From: Oswald, Hank
Sent: Thursday, December 15, 2016 3:15 PM
To: 'riley fenlon' (rfenlon0@gmail.com)
Subject: Floor Plan Request_B16005153

Building Permit Application

Permit No.: B16005153

FENLON HOUSE
ALTERATIONS AND ADDITION
13471 TRIADDELPHIA MILL ROAD
HOWARD COUNTY, MARYLAND

SITE PLAN

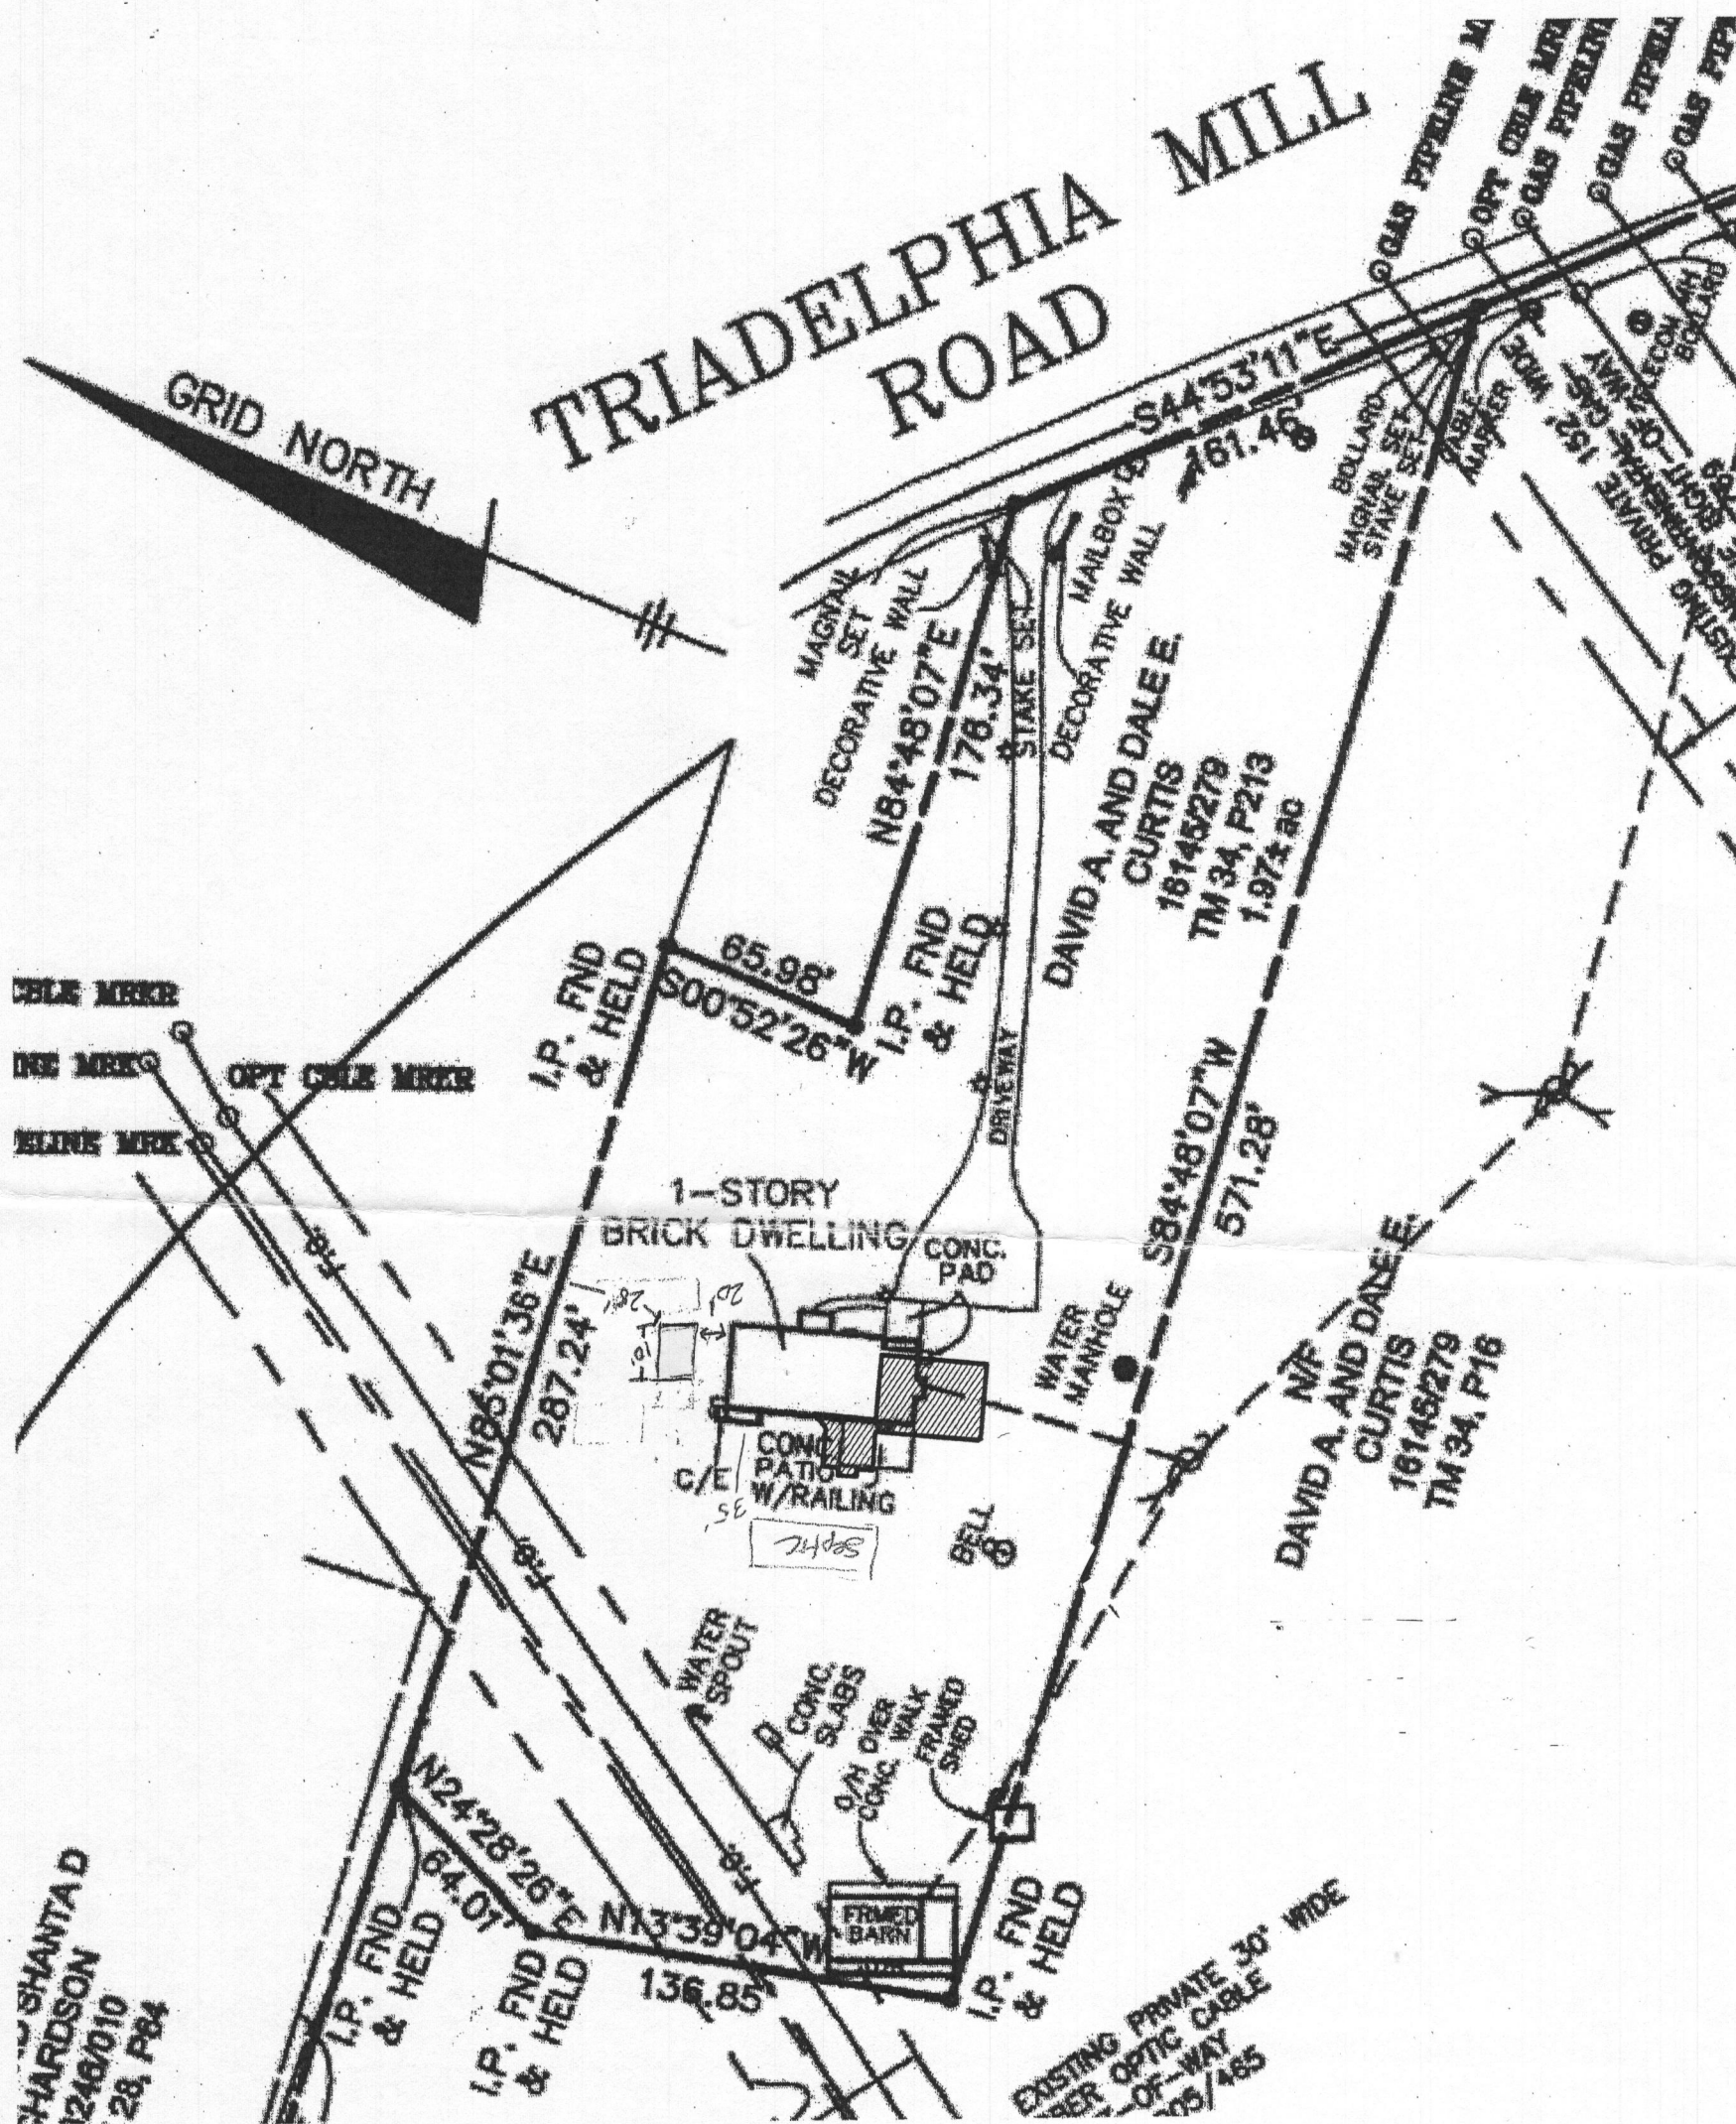
216112 - Site plan approved
as shown for B17000292
(500 gal 455) - H.O.
